200504215123 Received PERC OSEC 04/21/2005 08:36:00 PM Docket# CP05-32-000, ET AL.

RE: Docket Nos. CP05-32-000, 001
Applicant : Northwest Pipeline Corporation

Figure 1 - Location of Well House in Proposed Temporary Work Area.

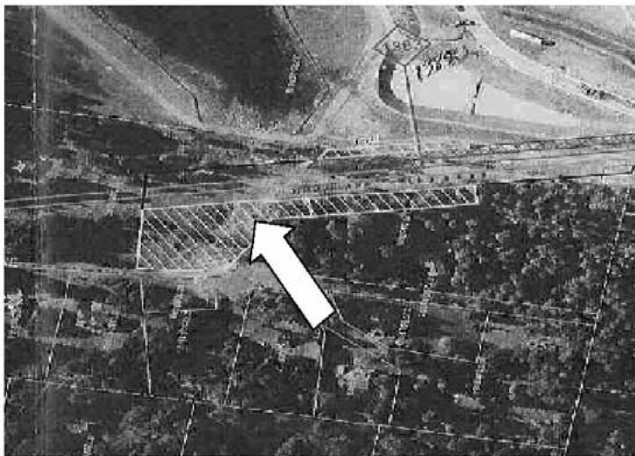
IND15-2 **3 Impact to Saddleback Well #752102**

At the lowest point of the proposed temporary work area is the Saddleback Well in our community. This is a private Group 8 community well (Saddleback Well #752102) that is the source of water for four families in this subdivision. Additionally this well provides the source of water for the maintenance of the common areas of the community. The location of this well inside the proposed work area is identified in Figure 1. Our subdivision of 10 families is concerned with the impact of this proposal on our well and subsequent water supply and would like to provide the following comments and concerns for consideration and submission into the public record.

- This temporary work area will create a terrain that will drain to the wellhead as it is located almost directly at the low point of this area and the modified area will drain directly to the wellhead.

IND15-2 Section 4.8.3.1 has been revised to include a discussion of the Saddleback Subdivision, including impacts associated with use of the proposed temporary extra workspaces on well number 752102.

Figure 2 - Proposed Alternate Site for Proposed Temporary Work Area

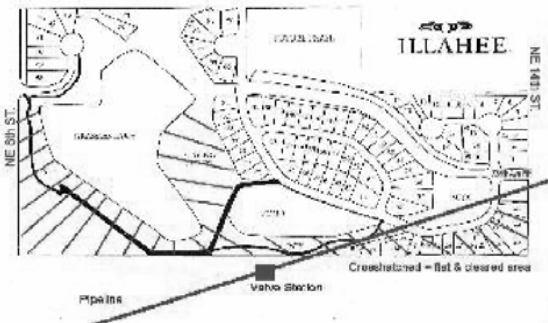
The main alternative that we see is a work area immediately to the west of the valve station. This area is currently cleared and flat. Access to this work area would be from NE 14th St and 236th Ave NE (see Figure 2) or from NE 8th St. Another alternative is the existing pipeline easement South of NE 8th St (see Figure 1). In addition there is another section of land adjacent to the pipeline that is undeveloped and its use should be explored (see Figure 3).

Section 4.8.3.1 has been revised to include a discussion of the Saddleback Subdivision, including impacts associated with the loss of trees and alternatives to the proposed access road and temporary extra workspaces.
